Environmental
Protection
Authority

Wheatstone Development – Gas Processing, Export Facilities and
Infrastructure – Inquiry under section 46 of the *Environmental
Protection Act 1986* to amend the implementation
conditions of Ministerial statement 873 relating
to the emission of greenhouse gases

Report 1732
January 2023

Inquiry under section 46 of the *Environmental Protection Act 1986*

Figure 1: Chevron’s proposed GHG emissions reduction trajectory

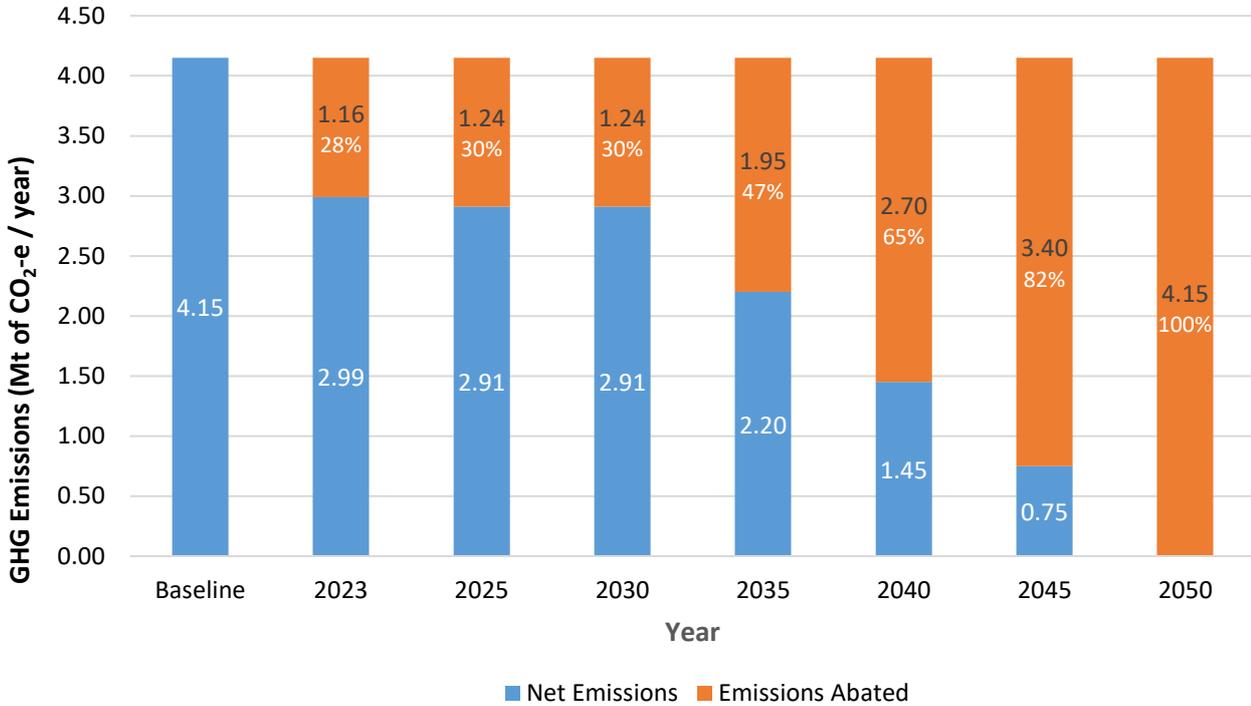
The EPA notes that Chevron’s trajectory does not include any reduction in GHG emissions for the period 1 July 2030 to 30 June 2035. Hence, GHG emissions reductions would remain unchanged at 30% over a 10-year period between 1 July 2025 to 30 June 2035.

The EPA is of the view that Chevron should be required to reduce GHG emissions by more than 30% during the period 1 July 2030 to 30 June 2035 in order for GHG emissions reductions to follow a more linear trajectory from 1 July 2025 down to net-zero by 2050. The EPA has determined that a reduction of about 38% (that is 1.6 million tonnes of CO₂-e / year) between 1 July 2030 to 30 June 2035 would achieve this. The EPA’s recommended GHG emissions reduction trajectory is shown in Figure 2 below.

Figure 2: EPA’s recommended GHG emissions reduction trajectory

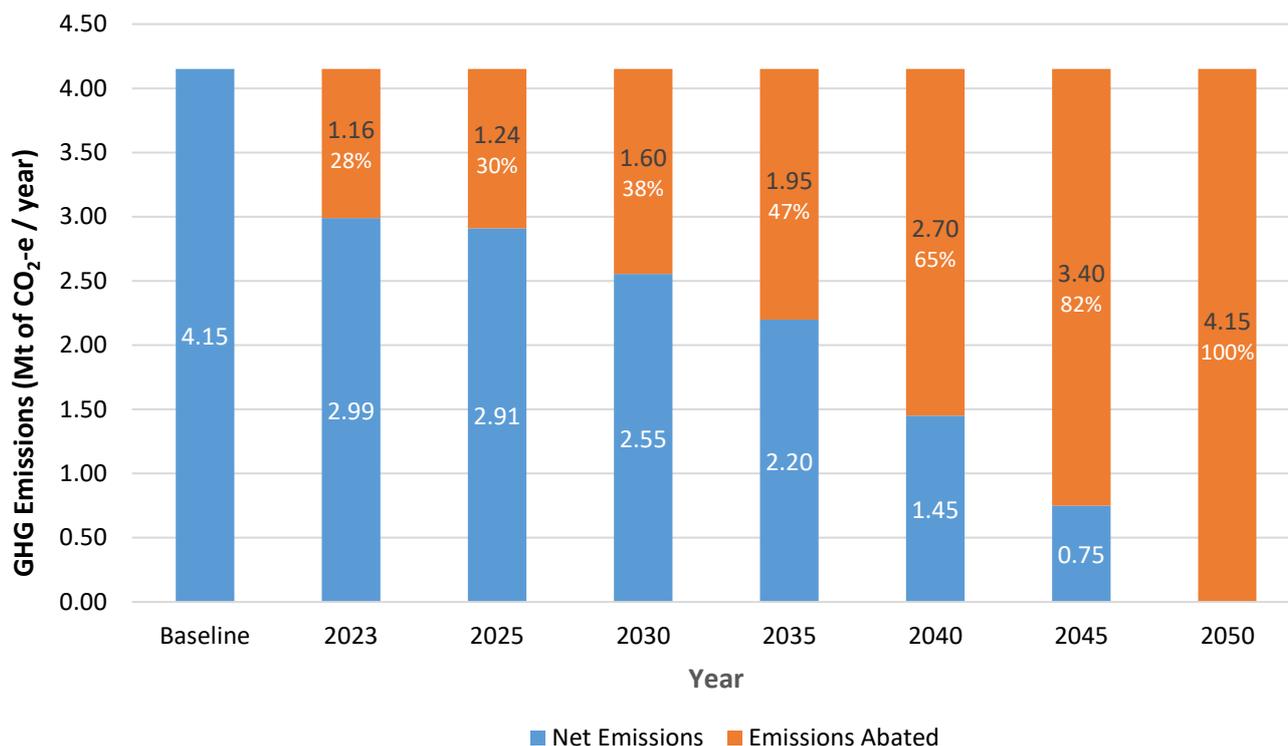
The EPA considers that the recommended trajectory shown in Figure 2 above represents a reasonable contribution to GHG emissions reduction in Western Australia. This is particularly important given that the Wheatstone Development’s processing emissions of 4.15 Mt of CO₂-e / year equate to approximately 5% of WA’s emissions in 2020.

The EPA has also determined that the recommended GHG emissions reduction trajectory is reasonable because:
